ADDENDUM: **TWO**

DATE: 10 March 2021

PROJECT TITLE: **LeConte College Maintenance Renovation (RE-BID)**
SC Project No.: H27-6126-LC
University of South Carolina

This addendum is issued to clarify and revise the Bidding Documents which have been previously issued.

A5
A6.22
ELEVATOR SILL DETAIL
1 1/2" = 1'-0"

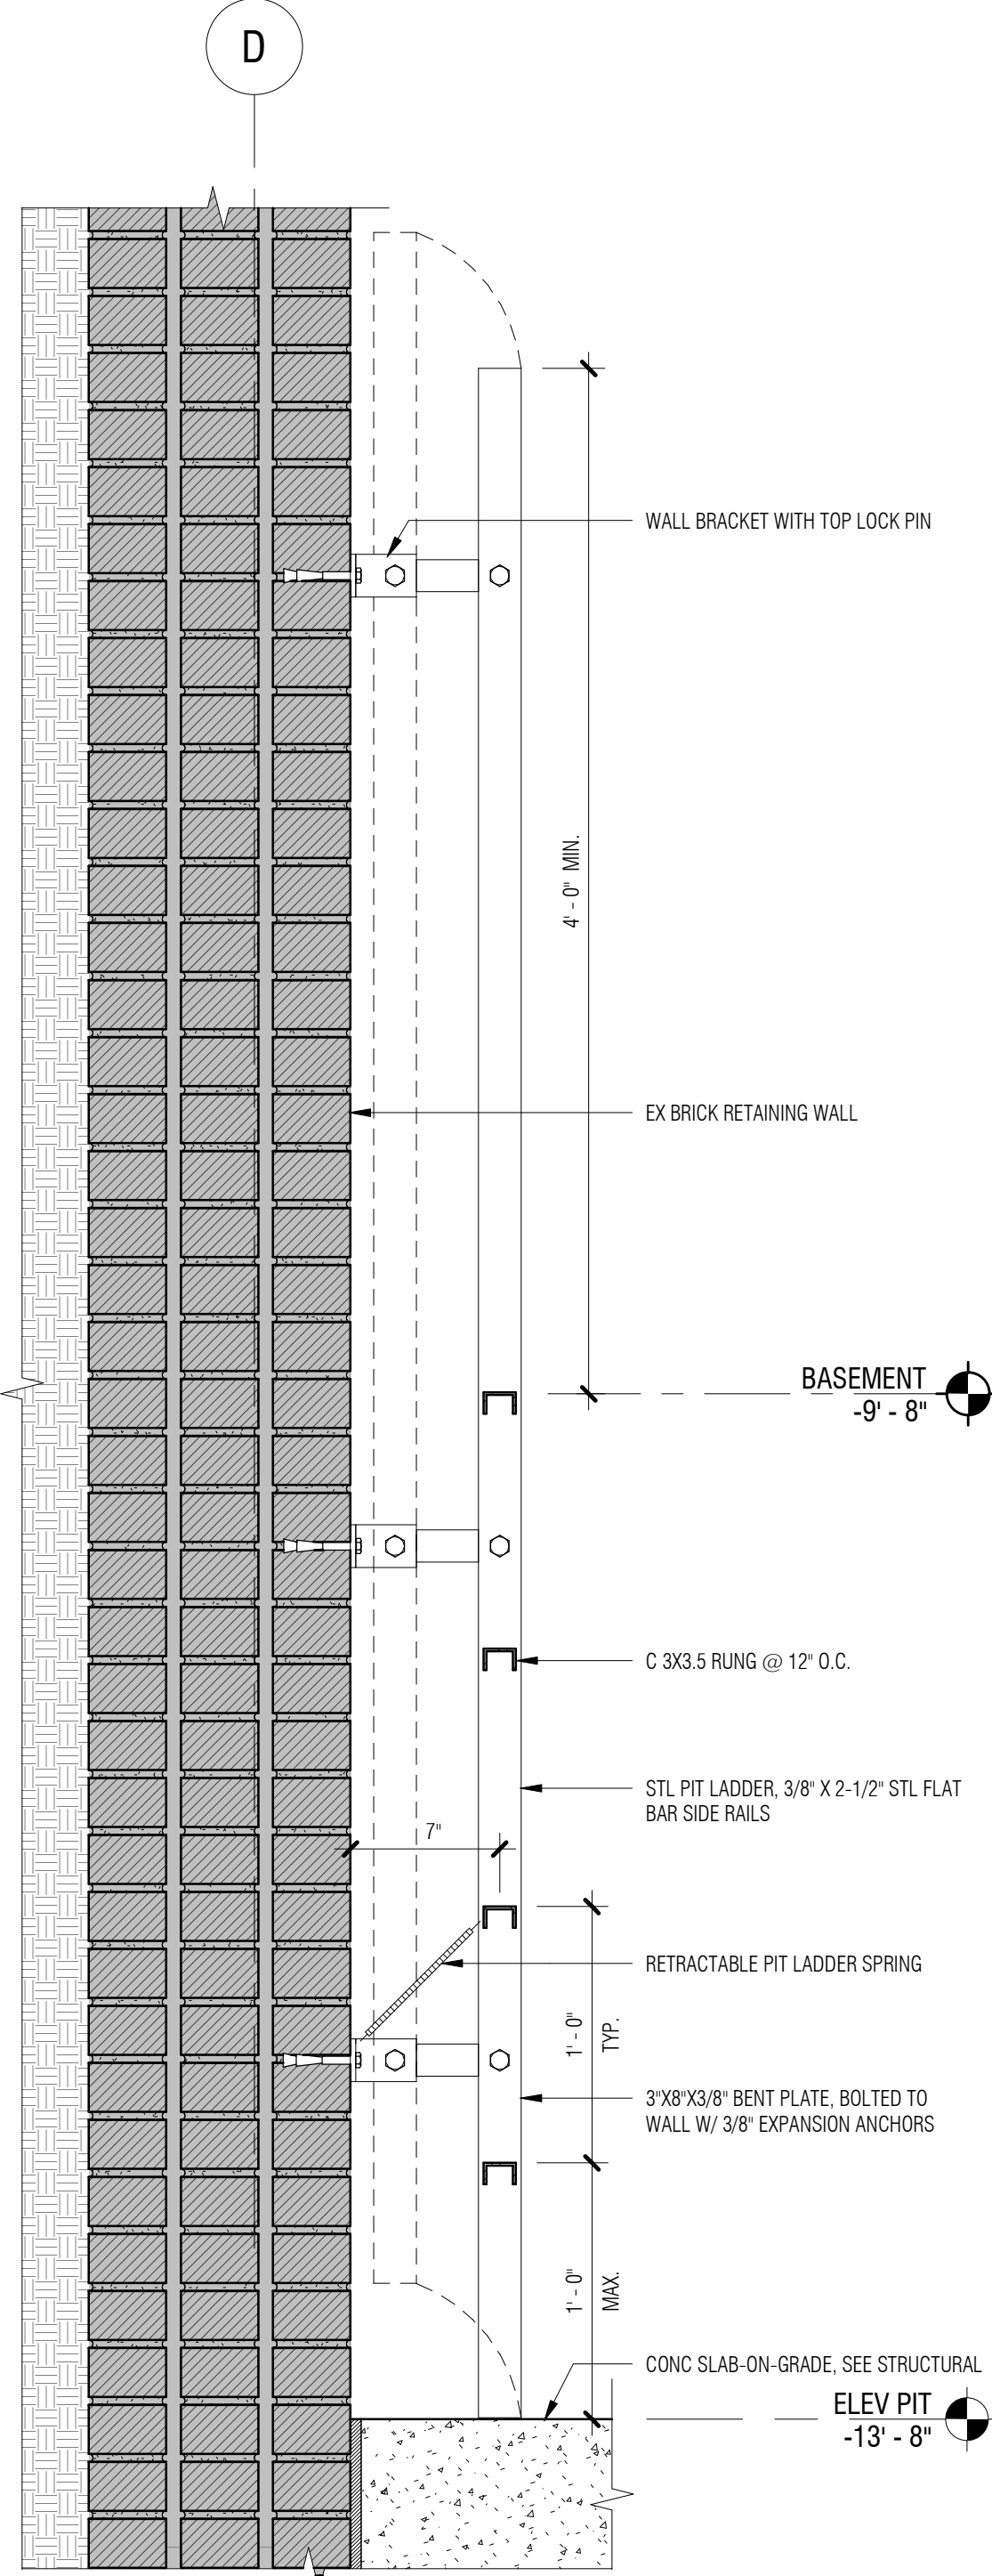
6. Details A4 and A5 on A6.22 at elevator and related sump pit call for spec 07 1700 Bentonite Waterproofing. We do not see this addressed in the Project Manual. Please provide.

8. Detail A5 on A6.22 shows horizontal and vertical porous fill around elevator pit and references structural. But the structural docs do not appear to address this issue. Please clarify.

Response: See revised sheets and added specification section in this addendum.

Response: See revised sheet A6.22 in the addendum.

BASEMENT HVAC PIPING PLAN
SCALE: 1/8" = 1'-0"

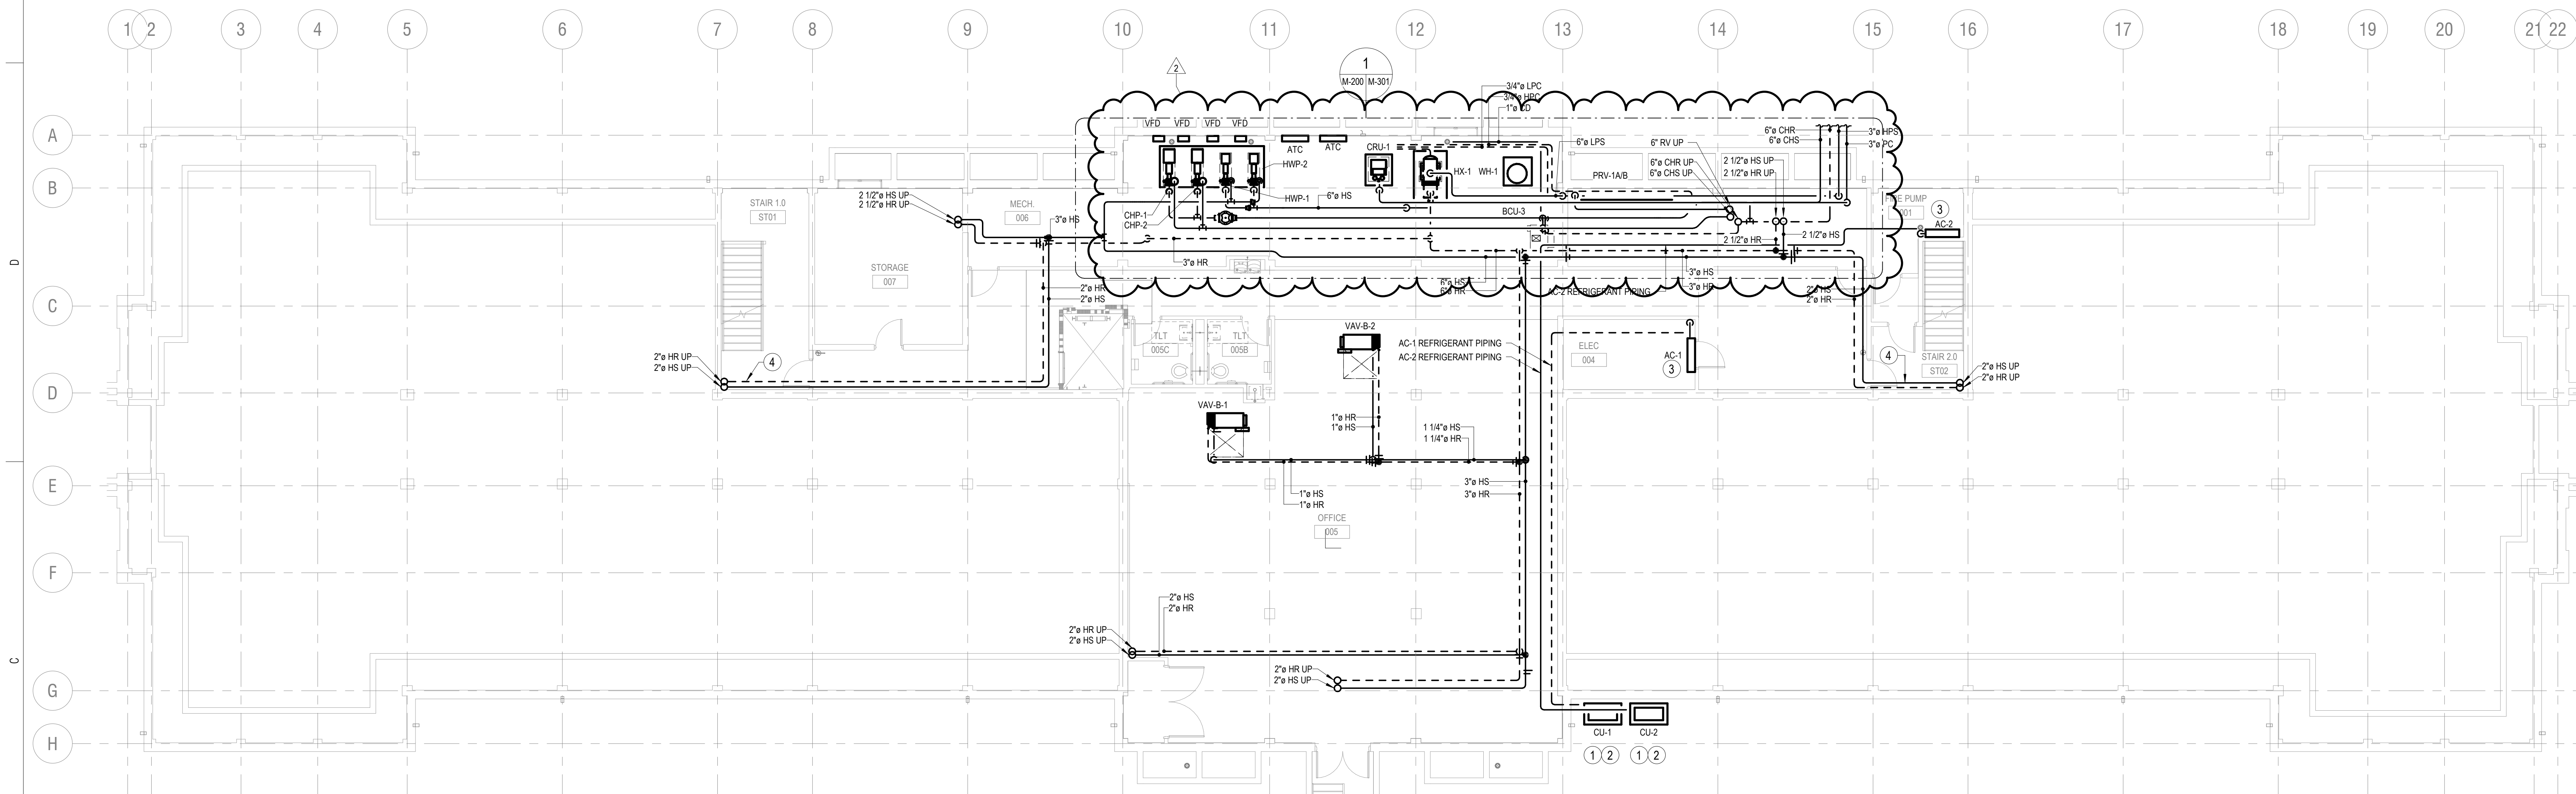
| 1. | <u>Drawing M-200:</u> Pipe sizes updated to match new chilled water flow rates. Added clarity for bridge decoupler installation. |

FIRST FLOOR HVAC PIPING PLAN
SCALE: 1/8" = 1'-0"

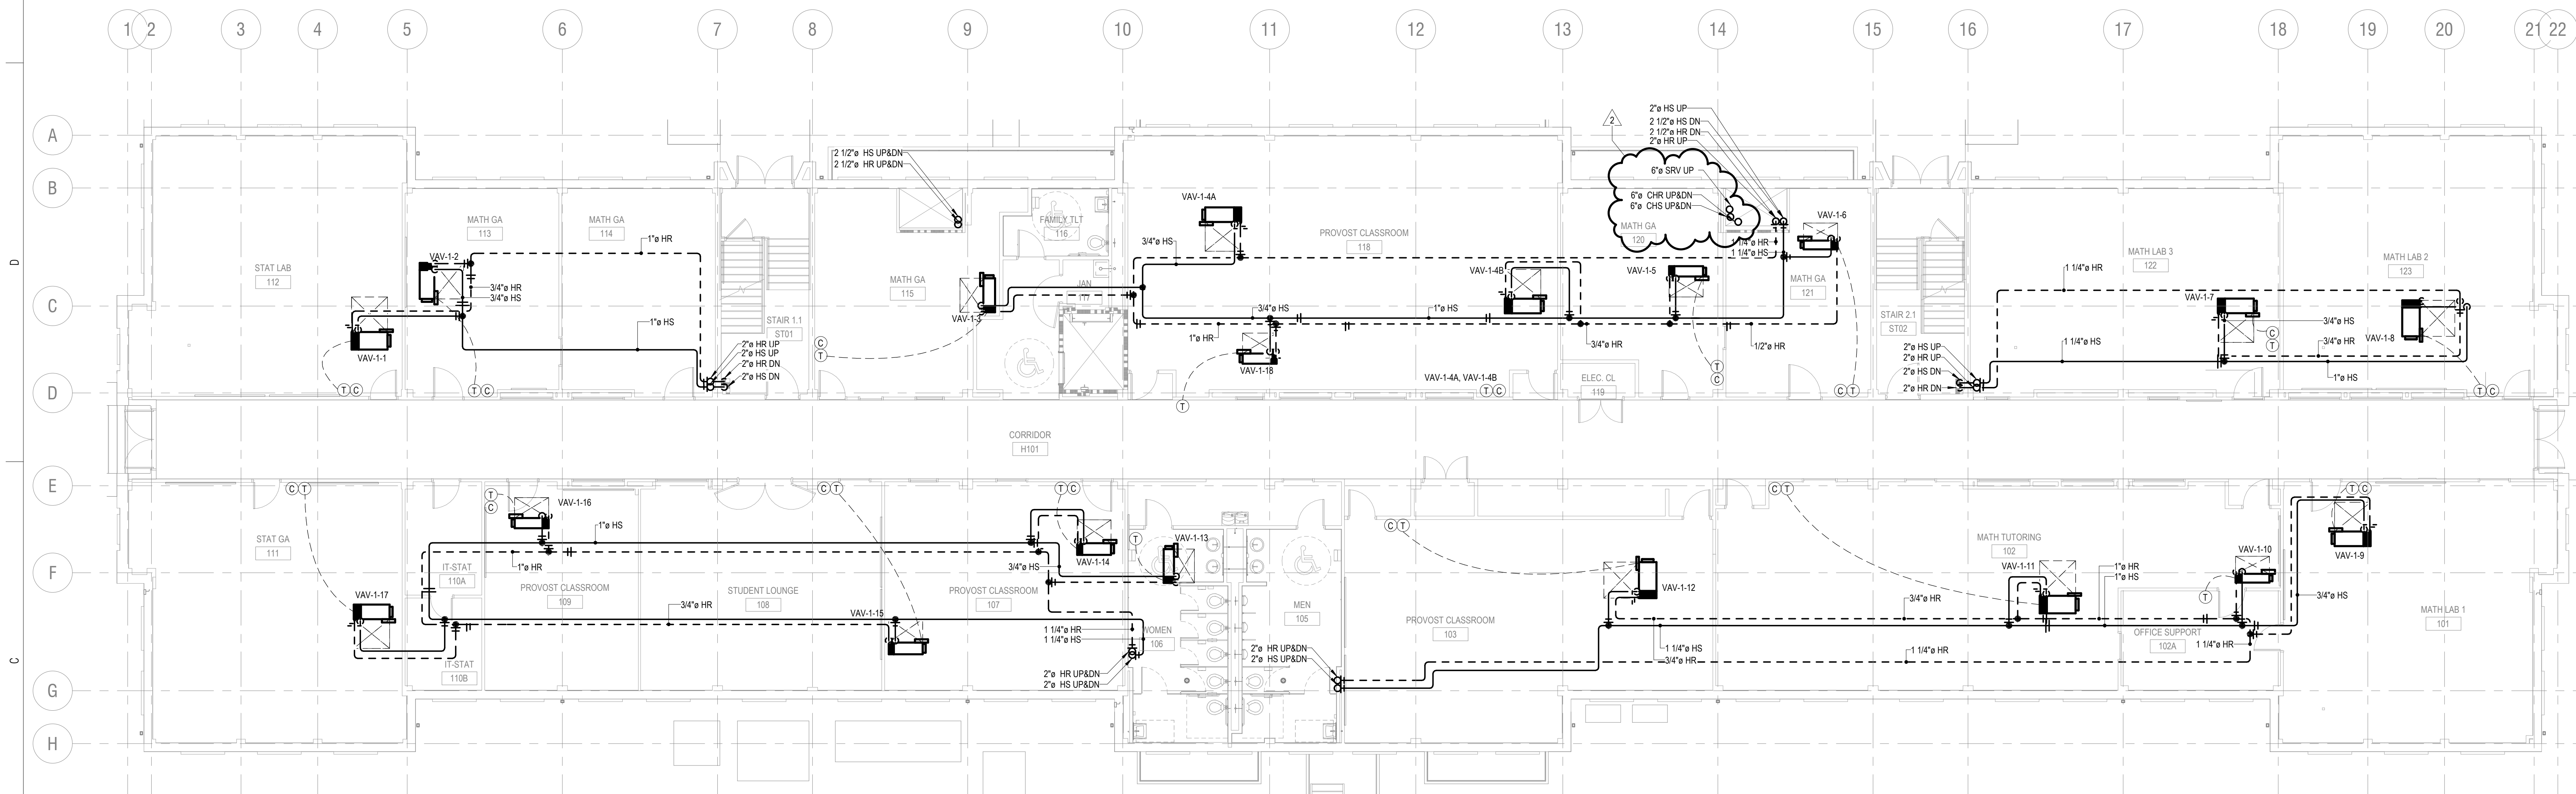
| 2. | <u>Drawing M-201:</u> Pipe sizes updated to match new chilled water flow rates. |

SECOND FLOOR HVAC PIPING PLAN

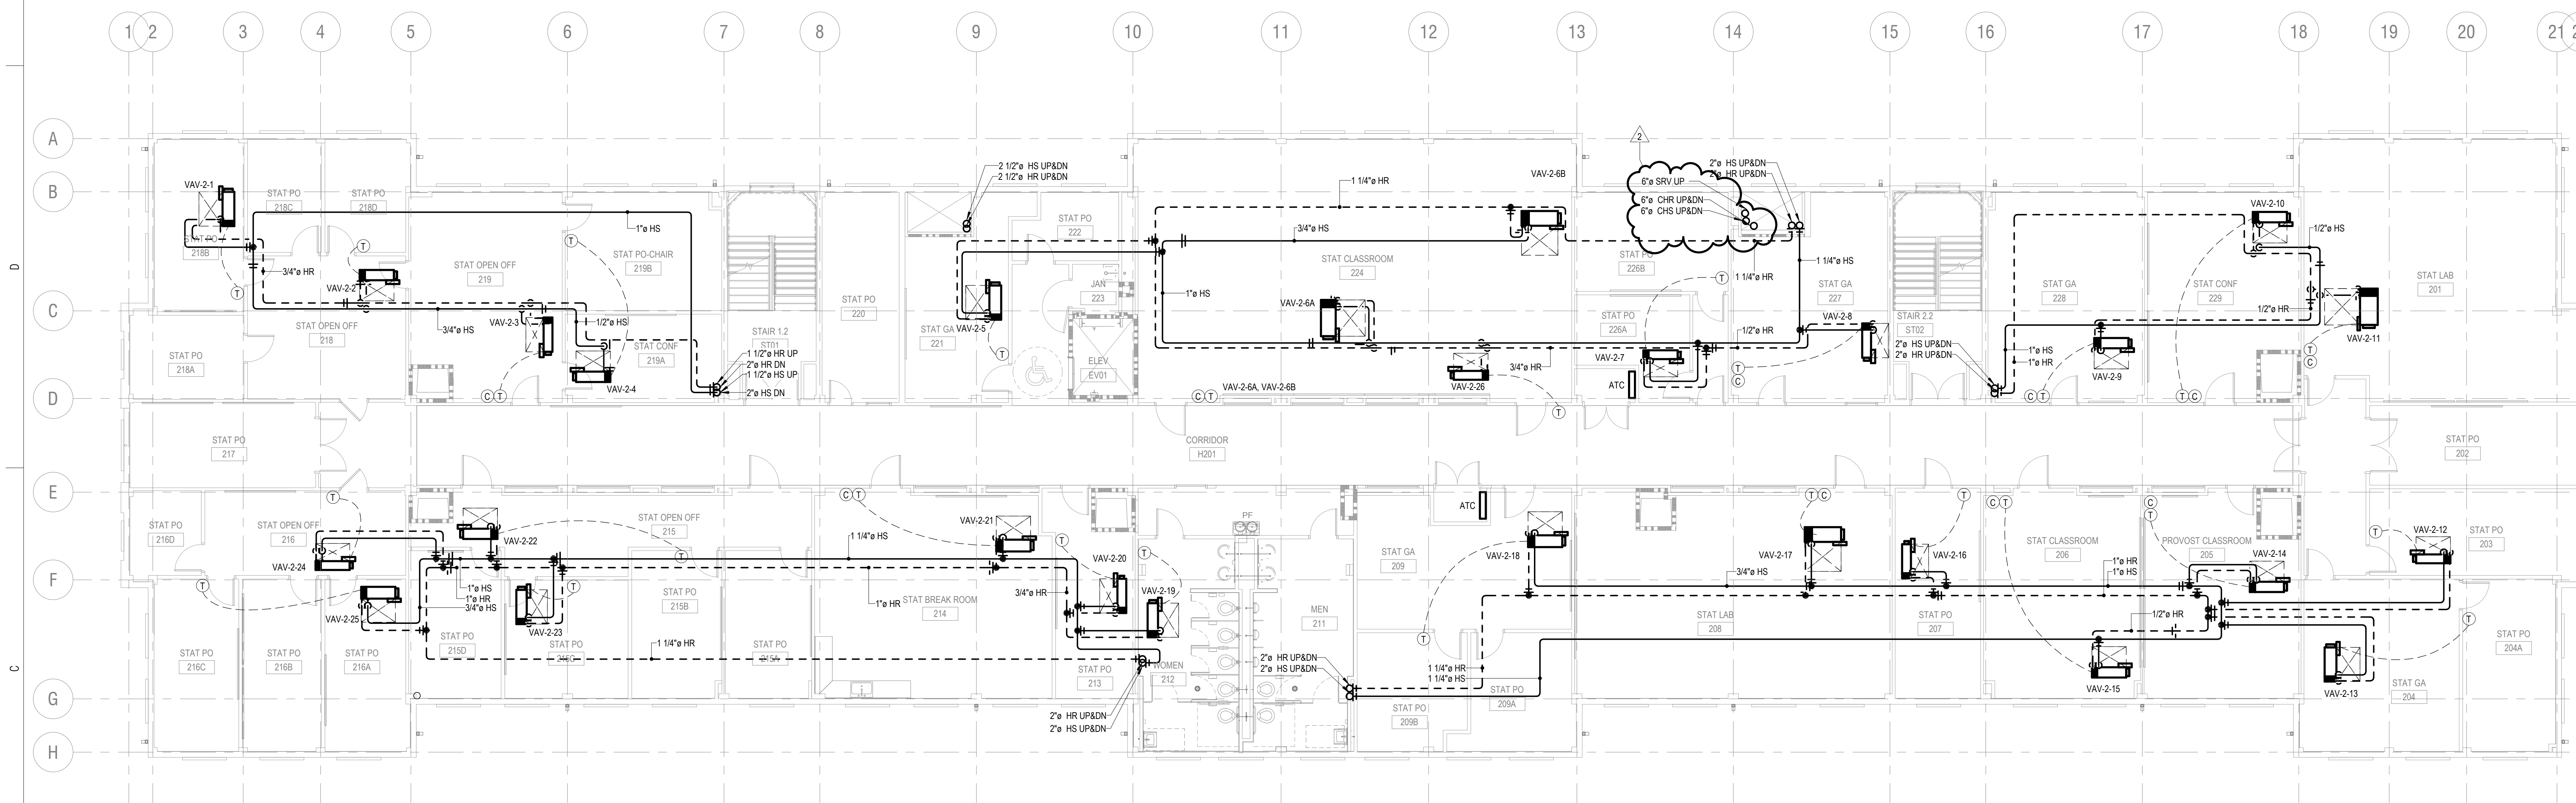
| 3. | <u>Drawing M-202:</u> Pipe sizes updated to match new chilled water flow rates. |

THIRD FLOOR HVAC PIPING PLAN

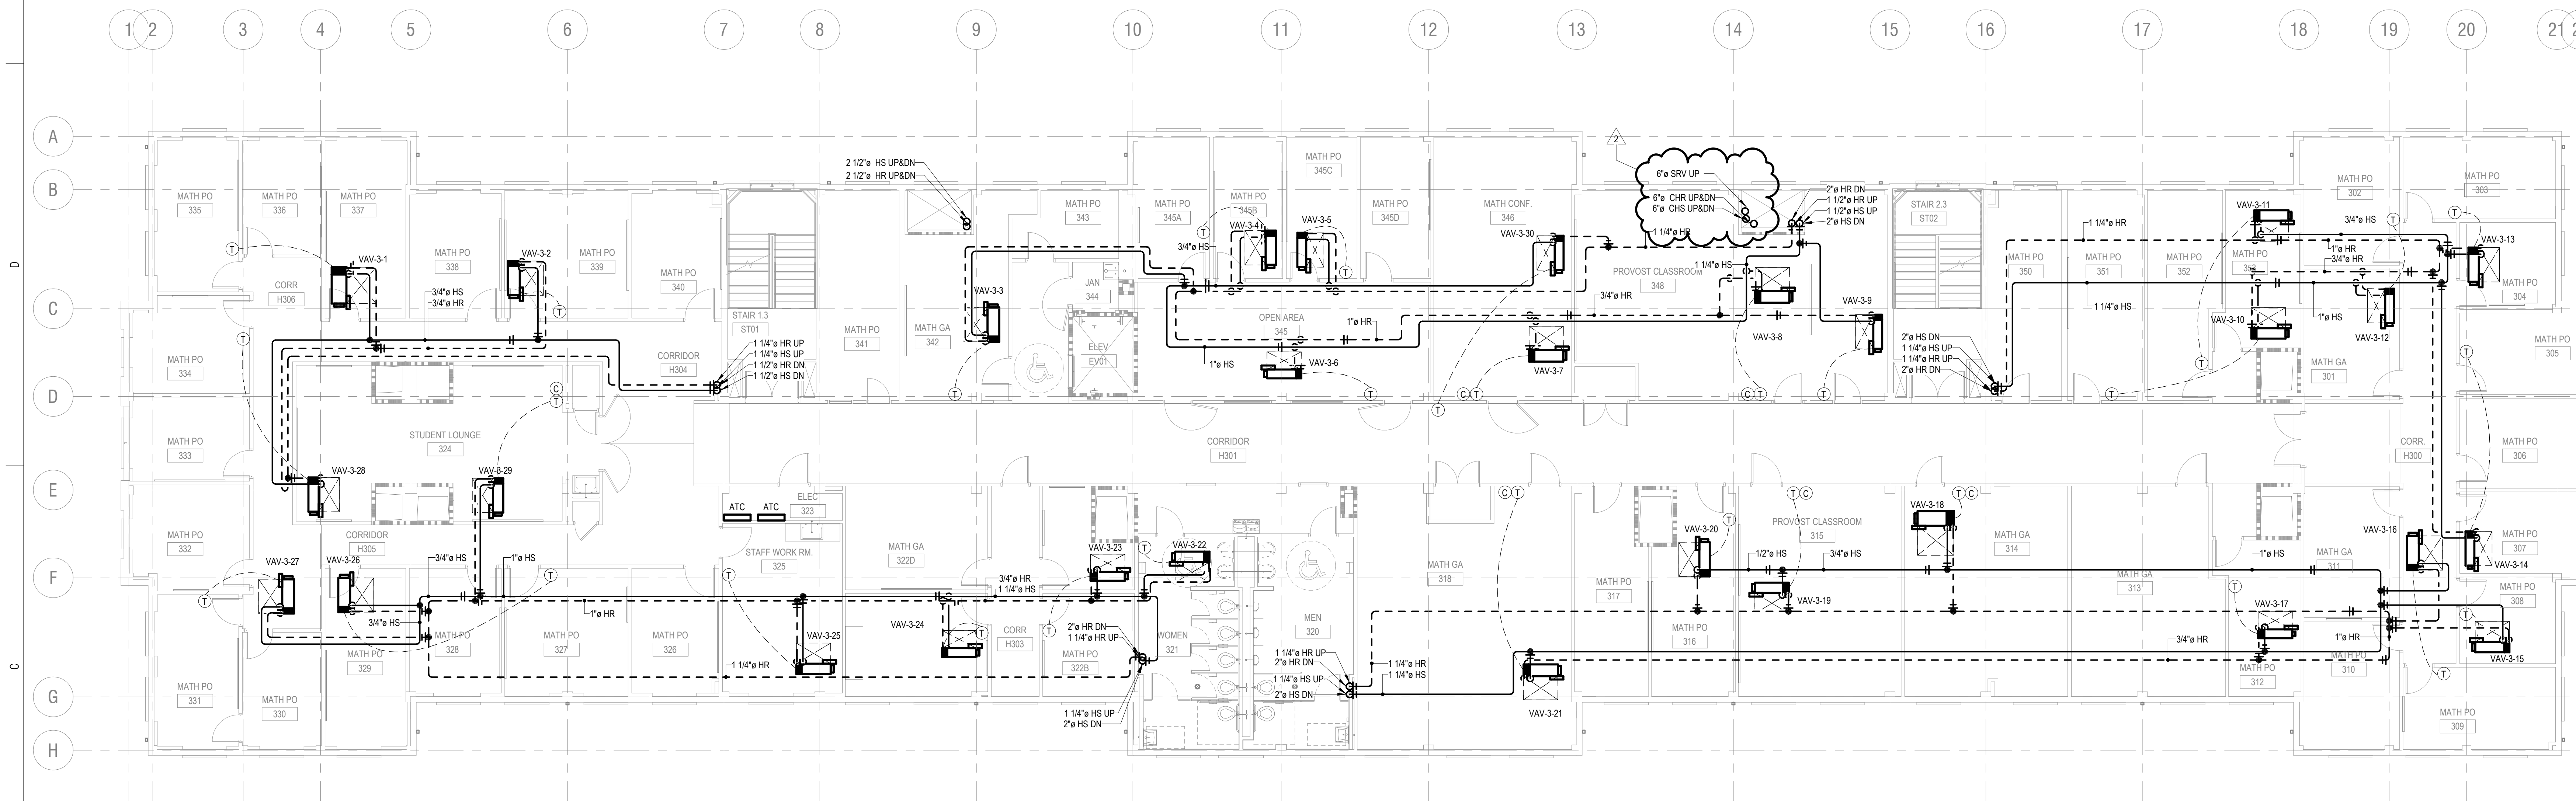
| 4. | <u>Drawing M-203:</u> Pipe sizes updated to match new chilled water flow rates. |
